ADDENDUM DESIGN STATEMENT

Change of Use to Upper Floors and Alterations
to create 46 Bedroom Hotel

1-3 York Street, Manchester

Fig 3: LEFT: previous corridor services strategy; RIGHT: Proposed services strategy introducing corridor ceiling rafts. Void spaces are highlighted in red.

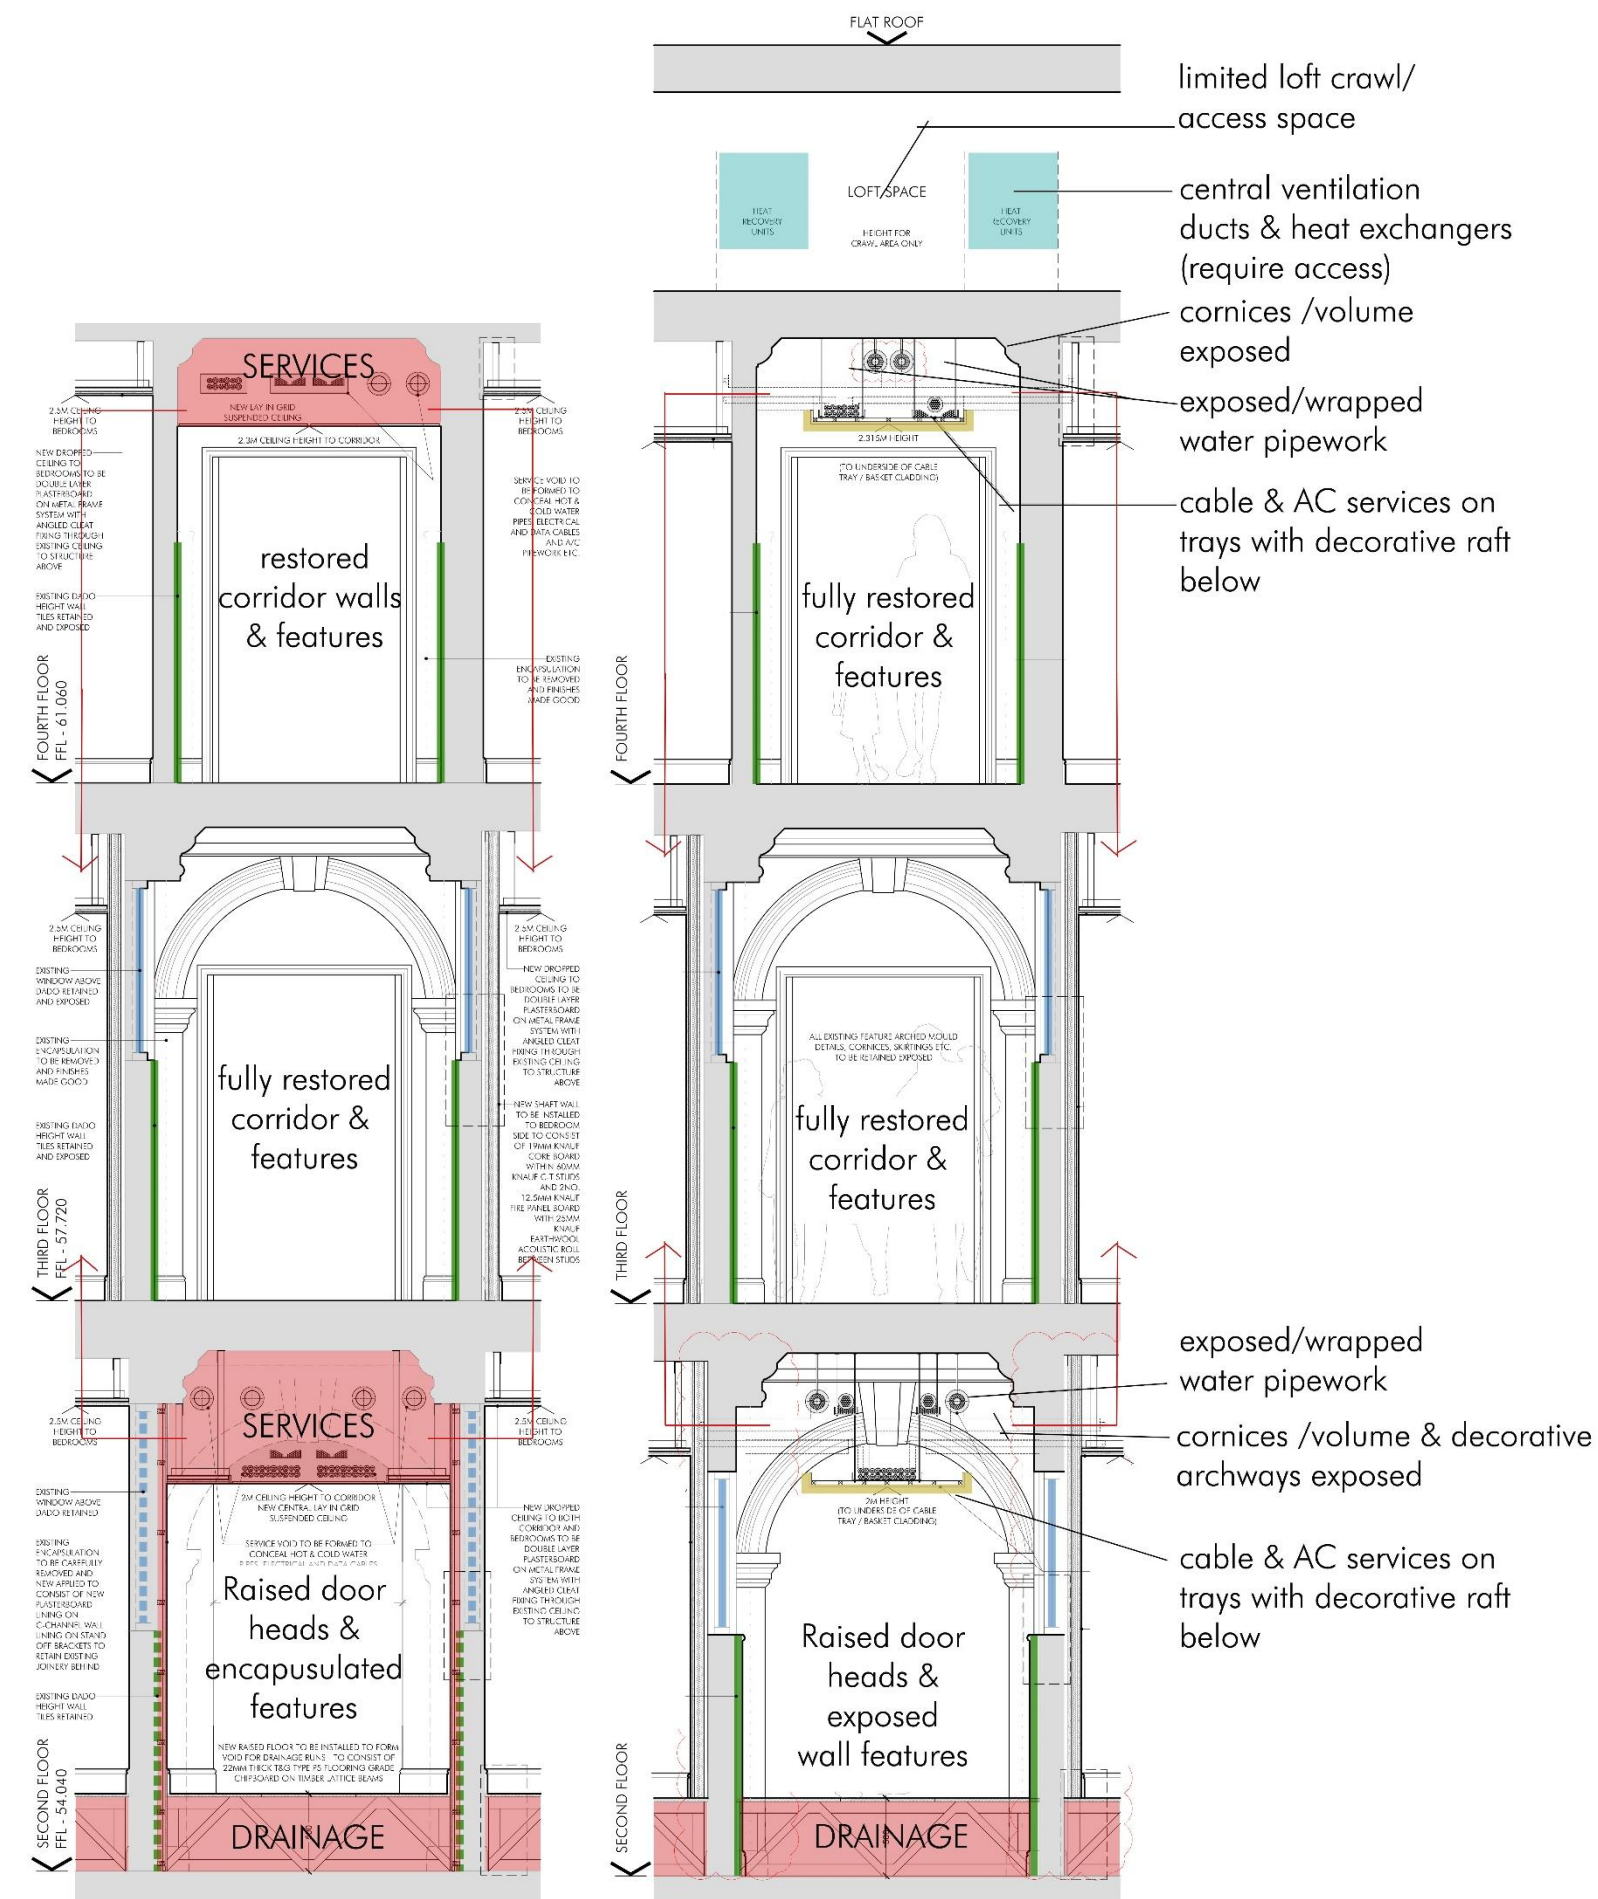
1.04	Dropped ceilings proposed to 2 nd floor should be omitted.	Corridor services – now show new short raft in lobby at 2 nd floor to keep fan lights to adjacent windows clear	1.2

6.0	<u>Works to ceilings and floors</u>		
6.01	Remove proposed suspended ceilings to corridor on second floor (entrance 'lobby' to corridor)	This 5'lobby' area has been amended to show a 'raft'-type ceiling in detail where services cross the corridor.	Illustrated in section 1.2

Following detailed consideration, we have redesigned the services distribution within the corridor ceilings to achieve the requested principle of carrying services on 'rafts' rather than boxing-in the full ceiling zone. The illustrations (opposite) show clearly the difference between the original approach and this revised proposal. The fundamental distribution principles for the whole building have not changed – services are concentrated at second and fourth floor level with vertical feeds through the bedrooms to enable the corridors at third floor level to be fully restored.

Fig 4: Plan extract showing M&E services (in red) diverted around section of corridor.

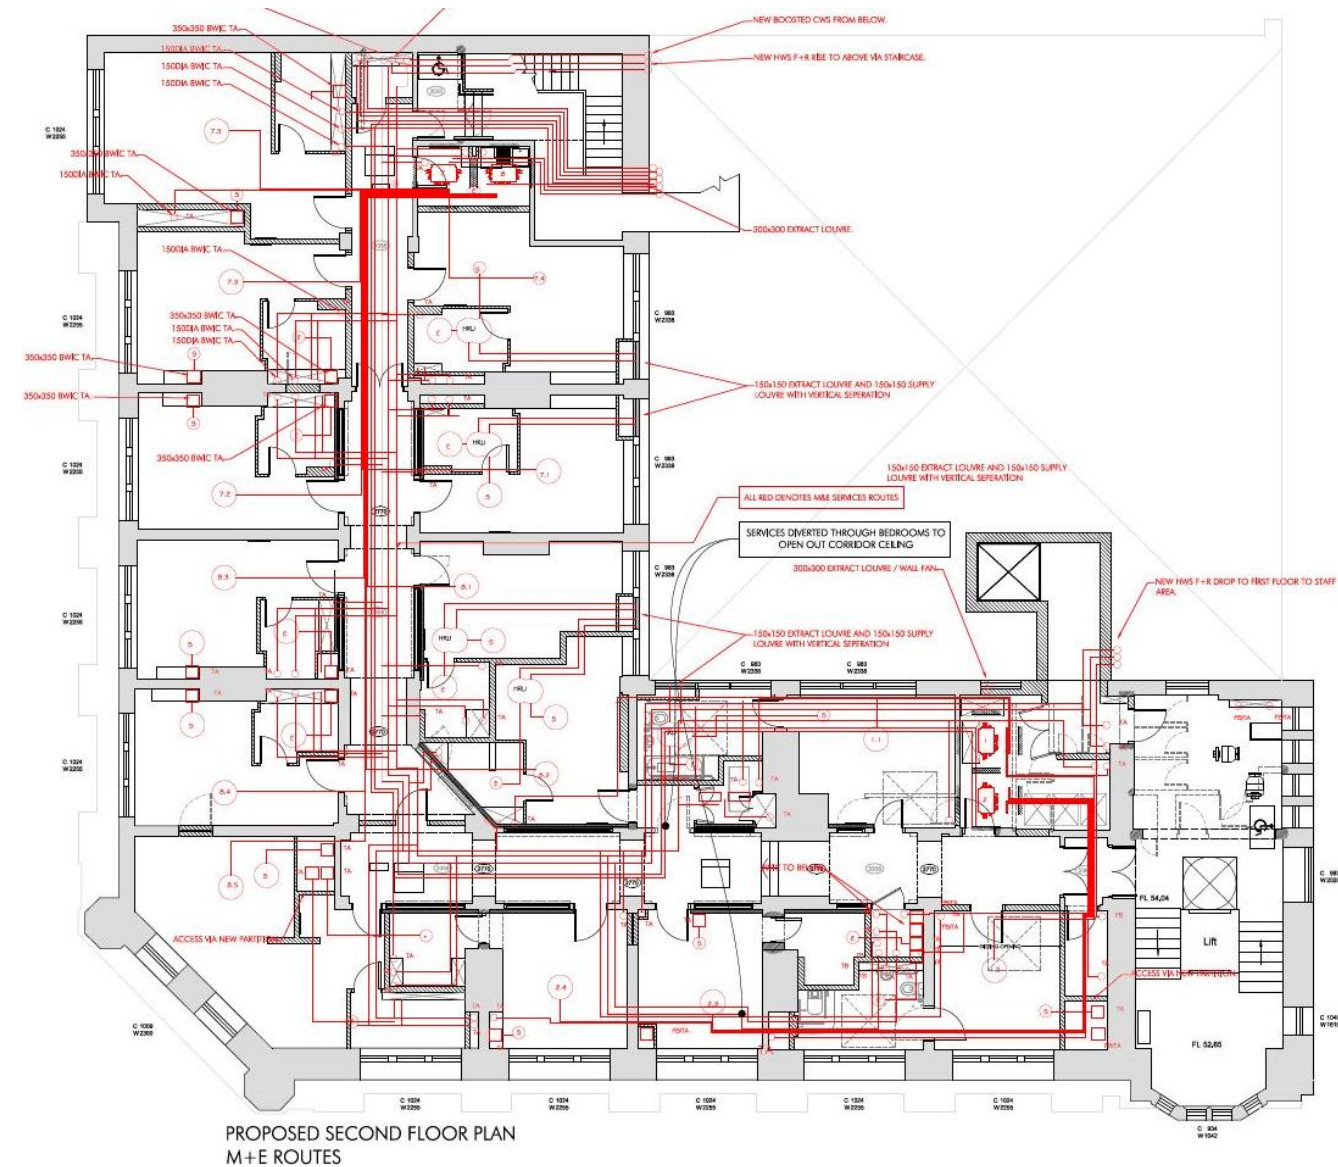
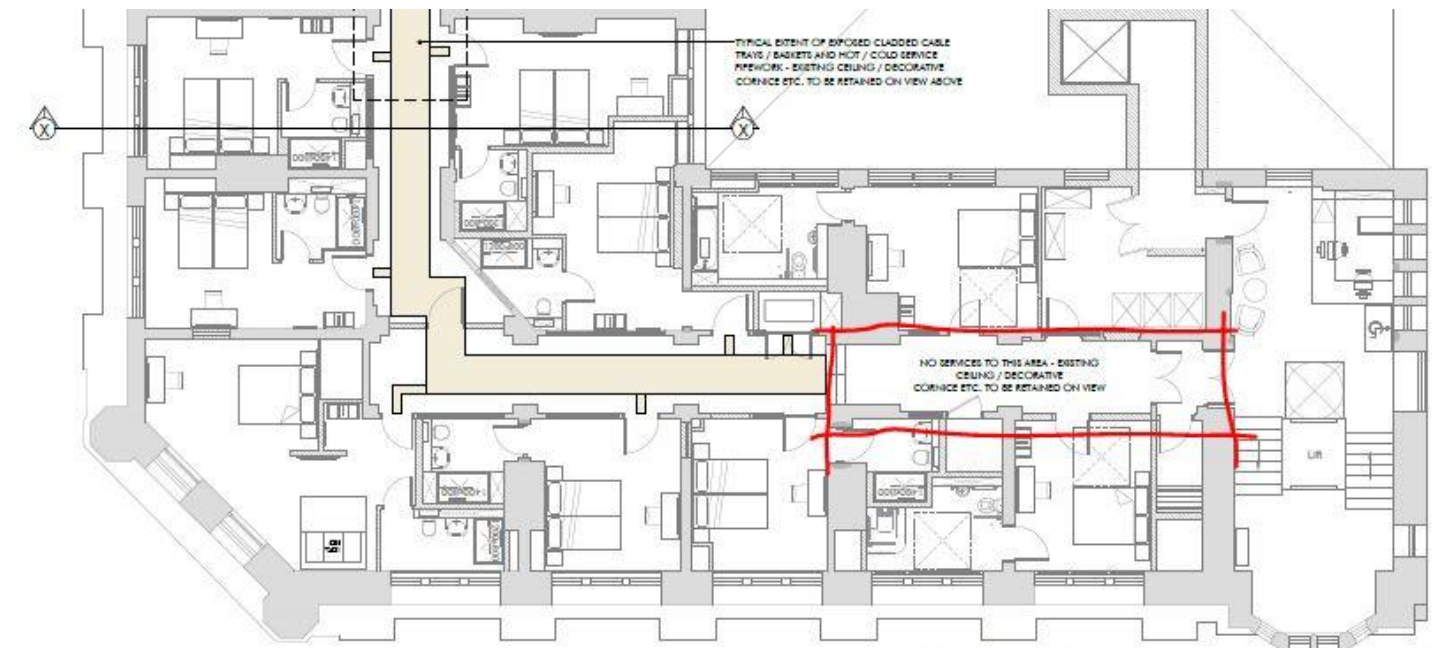
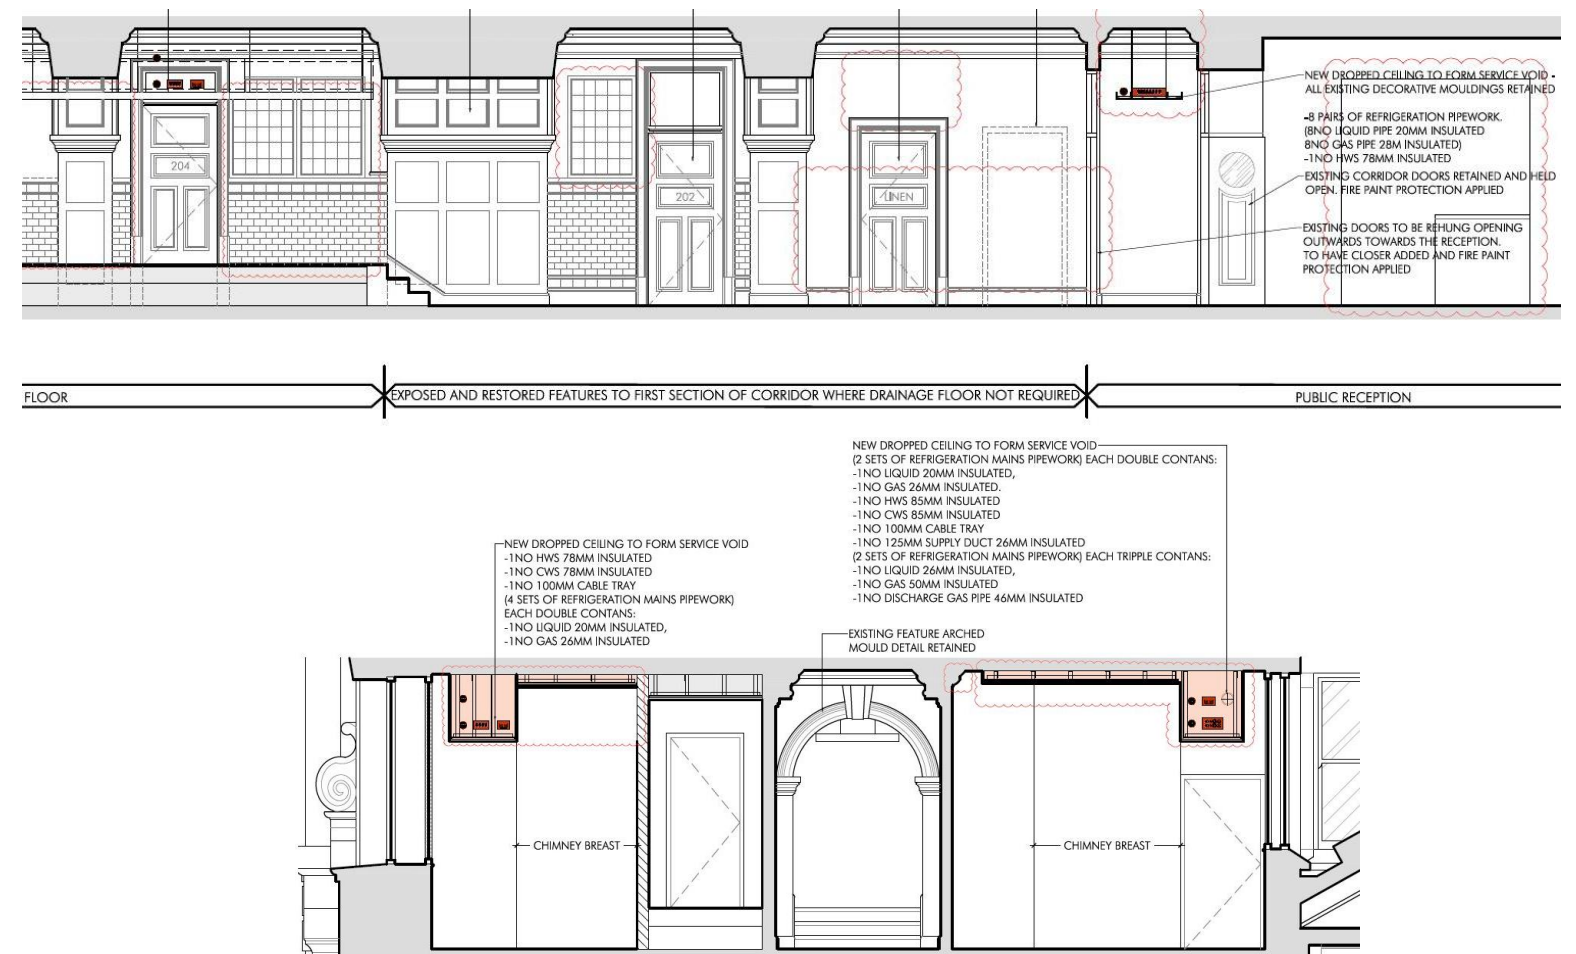
6.02	M&E services on 2 nd floor – need to give greater weight to the conservation of the asset through minimal interventions and 'rationalised' routes. Not currently the case - i.e. six new penetrations are proposed to apartment 206. Above ceiling M&E service routes as per drawing no. AP35B do not match proposed service routes as per drawing no. AP20.1A	Since receiving this comment, it has been verbally agreed with the LPA that the M&E drawings provided are to be considered indicative only in terms of exact positions and groupings of pipework. They have been worked out from an M&E technical perspective (i.e. correct numbers and sizes), but they are diagrammatic. In reality, for example, air conditioning pipes shall be paired, water pipes shall have individual holes, but will be grouped, cables shall be grouped with a single penetration. The typical grouping details indicated on APP (architectural) drawings are more typical of the final installation. This aspect of detailed M&E design may be conditioned if felt necessary, but the APP drawings establish the correct principle.	1.2

The only exception to this general principle of corridor ceiling services rafts is at second floor, to the initial section of corridor directly accessed from the proposed reception area. This area does not require a raised floor therefore, as in the original application drawings, we are proposing to fully restore that section of corridor, including the tiled walls full height, by routing services through the rooms to either side of it. This results in a larger section of bulkhead ceiling in those few side rooms, however there is a clear benefit to the user experience of the building by allowing that section of corridor to be restored. The restored section of the corridor is more 'on show' to the general public, being both a general access corridor and immediately adjacent to, and visible from, the reception area.

Fig 7: LEFT: Extracts from D&AS Section 2.14; ABOVE extract from rear elevations drawing; RIGHT detailed section through sash windows. *

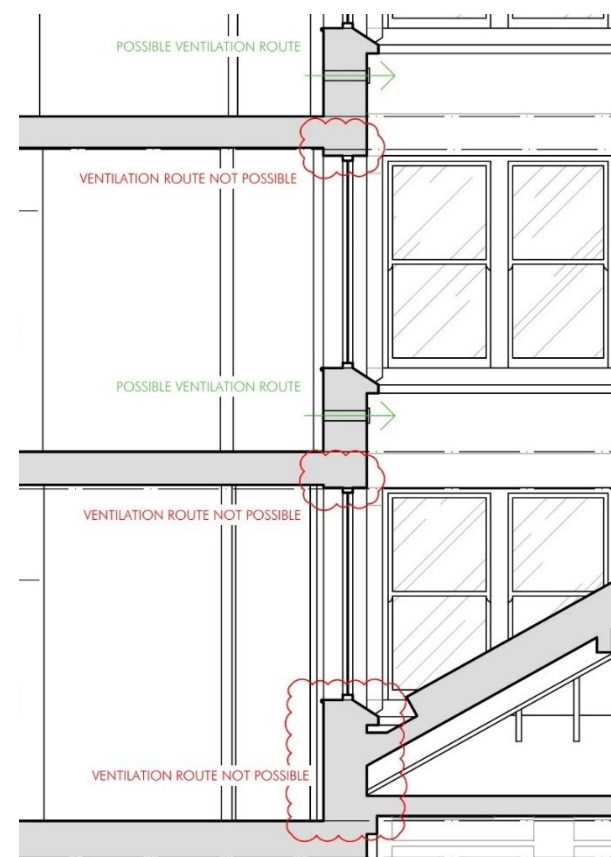
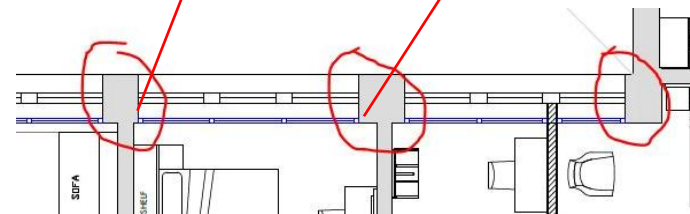
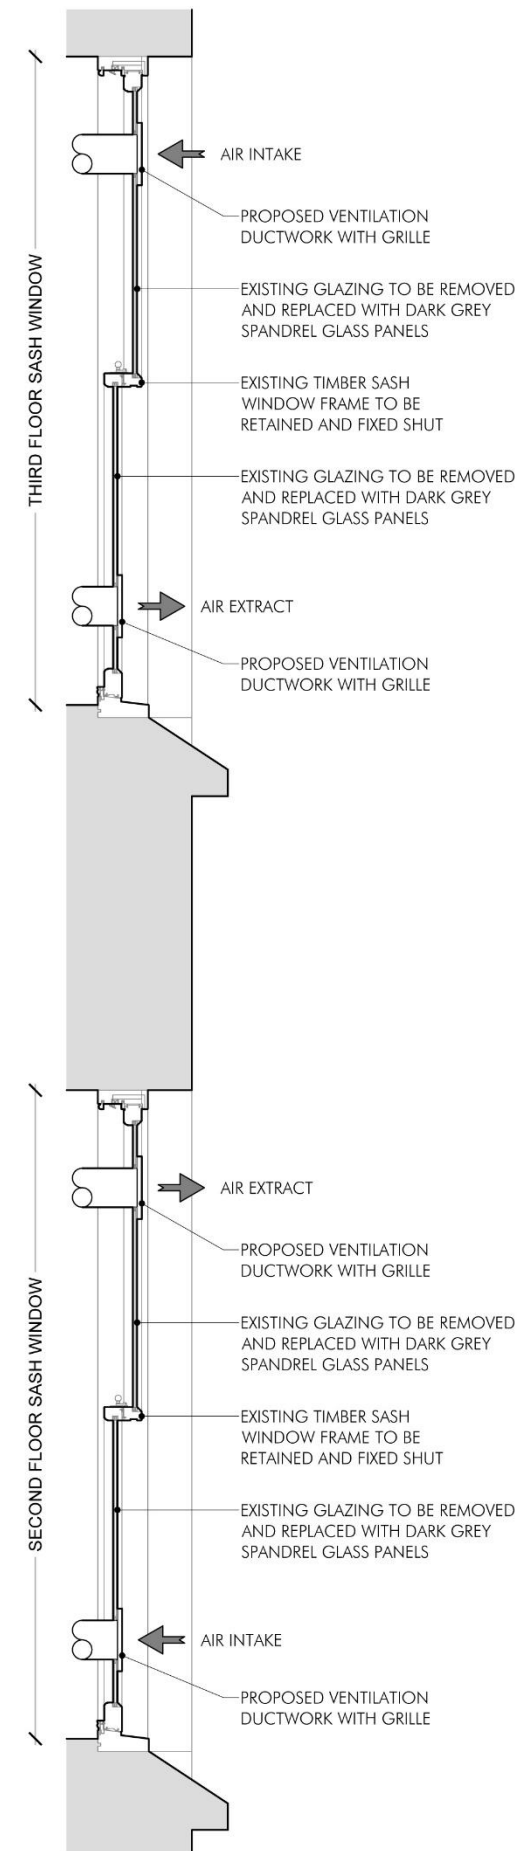
- Retain ventilation grilles in rear (courtyard) windows. Confirm that the number of vents is the minimum needed and that it is not possible to impact one sash as opposed to both sashes.

Following the first site meeting with the planning Case Officer, it was established that the preferred method of ventilation to the rear bed/shower rooms to 2nd and 3rd floors is to take individual vents through windowpanes in order that this change is readily reversible. Each room requires an input and extract air vent which must be spaced apart by at least 1 metre to avoid undesirable re-circulation of exhaust air. The upper floor can be directly vented through the roof space. There is limited roof void space to accommodate a central ventilation system for these rooms – preference has been given to providing a central extraction system to the front façade where it is not possible to provide direct façade ventilation without a detrimental visual impact.

In order to achieve the required ventilation within the windowpanes with minimal visual impact to the rear, we are proposing to re-glaze the existing sashes with an opaque grey ceramic spandrel glass, with individual cut-outs for single air vents. As before, the affected windows are entirely obscured from view at street level by the courtyard pyramid roof, and mostly obscured by the pyramid roof when viewed from the adjacent office buildings. Using a glazed-in method, the existing sash windows can be retained or refurbished and the impact on the building fabric is limited and easily reversible.

Although the above opinion on the reversible and inobtrusive nature of this proposal was supported by the Planning Case Officer, further Conservation Officer comments have suggested openings drilled through brickwork would be preferable, and that we should show in detail why this is not possible. This is illustrated in the D&AS section 2.14 (page 13) – part reproduced below – demonstrating that there is insufficient depth at window head to 2nd & 3rd floors and a clash with roof structure at second floor cill level. The photograph to the right, also taken at second floor, and highlighted plan extract shows there is generally insufficient width of masonry at the window jambs to accommodate a core drill hole (about 125mm diameter would be needed, while leaving masonry surrounding it to maintain structural stability).
